Attached please find three documents containing questions I have regarding Case No. SUB-UGA-SPR-ADJ-TRV-DR23-02 for 2100 Block of Doaks Ferry Road NW.

Query 1: Titan Hill Development Setback Identification Labels

Query 2: Significant White Oak Remove Variance Questions

Query 3: Half- Street Development Questions

The graphic below is an enlarged segment of the applicant's drawing **SDR8** at the intersection of Parcels 5 and 6 and Doaks Ferry Road.

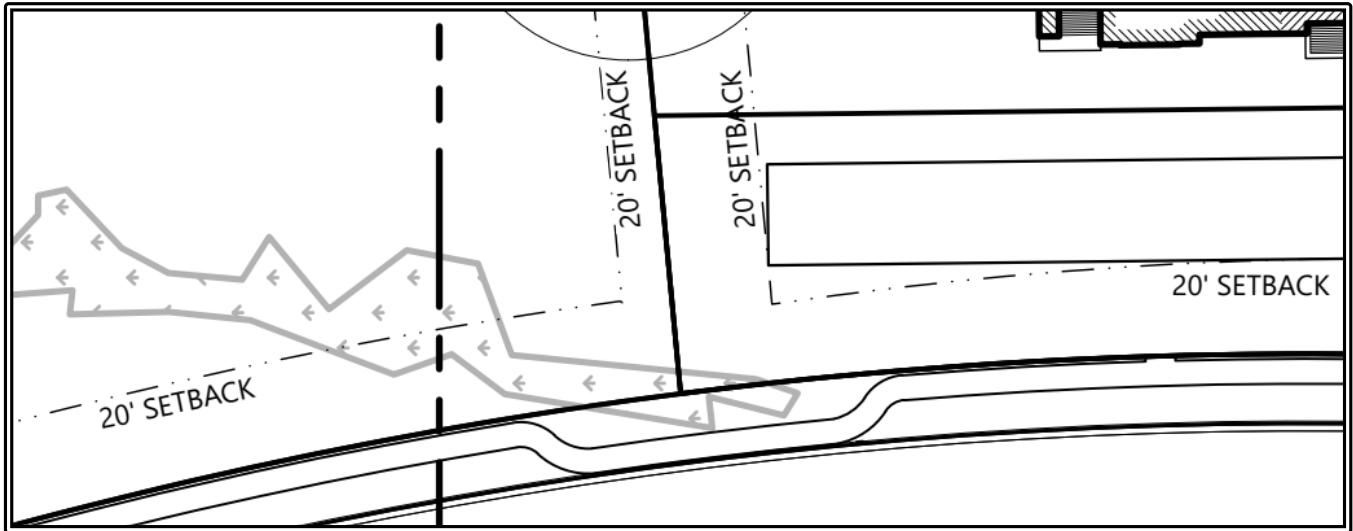
1. Why is the Parcel 6 setback distance of 20' from Parcel 5 not identical to the other 20' setbacks?
2. Why is there no identification or labeling of the 75-foot riparian setback from Wilark Brook?

Final SDR3 southeast segment

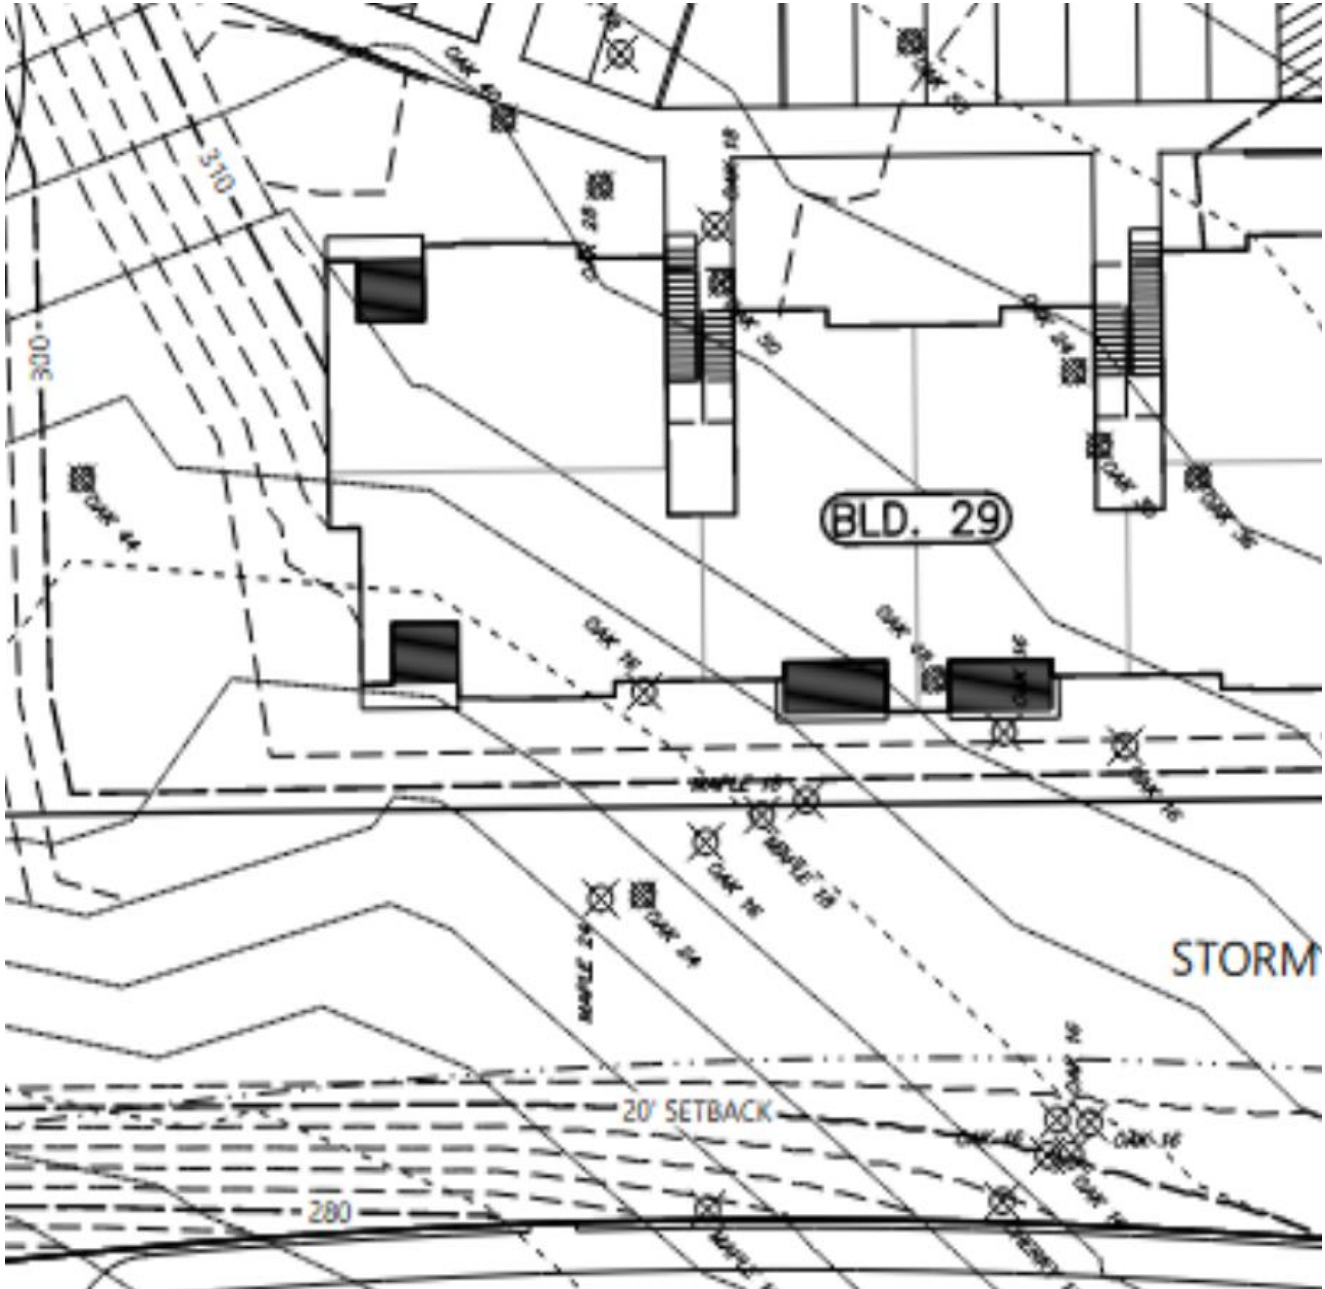
Why are the significant white oaks trees to be removed not numbered as they are on the preliminary **SDR3** sheet segment shown on the next page and cataloged on the applicant's tree variance request sheet?

Why is Oak 1 slated for removal?
